# Access Compliance Report

## Public Rights-of-Way

### (Curb Ramps)

Intersection ID: 26390	Main Street: BAYBROOK_LN	Cross Street: BEVINGTON_PL	Location: NW
ADA ID: BF67D9EF414C	Ramp Type: PerpDiag	Initial Pass/Fail: Fail	Overall Compliance: No
		Severity Score: 12.5

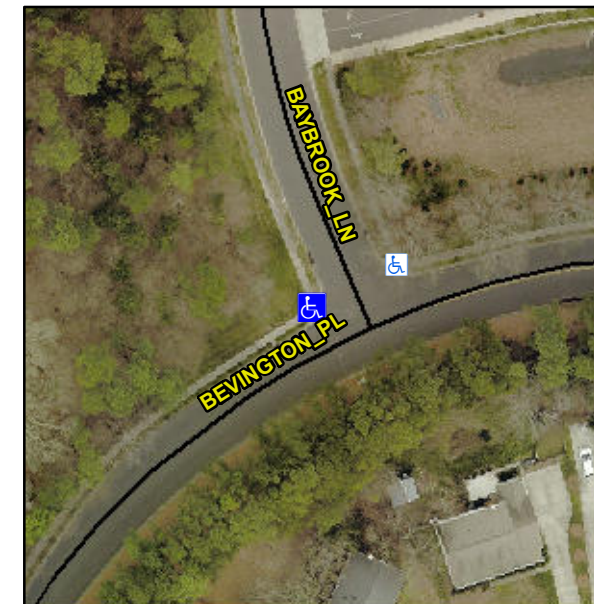
**R304.2.2**

Compliance	Description	Data	Compliance	Description	Data
N/A	Ramp Length (in)	79.0	No	Ramp Slope (%)	8.6
Yes	Ramp Width (in)	48.0	Yes	Ramp XSlope (%)	0.4
N/A	Flare Type LT	N/A	N/A	Flare Type RT	N/A
N/A	Flare Slope LT (%)	N/A	N/A	Flare Slope RT (%)	N/A
N/A	Flare Traversable LT?	N/A	N/A	Flare Traversable RT?	N/A
N/A	Landing Length (in)	N/A	N/A	DWS Provided?	N/A
N/A	Landing Width (in)	N/A	N/A	DWS Contrast?	N/A
N/A	Landing Slope (%)	N/A	N/A	DWS Length (in)	N/A
N/A	Landing X Slope (%)	N/A	N/A	DWS Full Width?	N/A
N/A	Landing Curb? (Y/N)	N/A	N/A	DWS Offset (in)	N/A
N/A	Shared Landing?	N/A			
N/A	Gutter Ponding?	N/A	N/A	Gutter Slope (%)	N/A
N/A	Gutter Lip Ht (in)	N/A	N/A	Gutter X Slope (%)	N/A
N/A	Painted X Walk1?	No	N/A	Painted X Walk2?	No
	X Walk 1 Direction	To SE		X Walk 2 Direction	To NE
N/A	X Walk 1 Width (in)	N/A	N/A	X Walk 2 Width (in)	N/A
	X Walk 1 Slope (%)	3.4		X Walk 2 Slope (%)	1.5
	X Walk 1 X Slope (%)	1.6		X Walk 2 X Slope (%)	0.3

**Remove & Replace Curb Ramp With Two New Directional Ramps or Equivalent.**
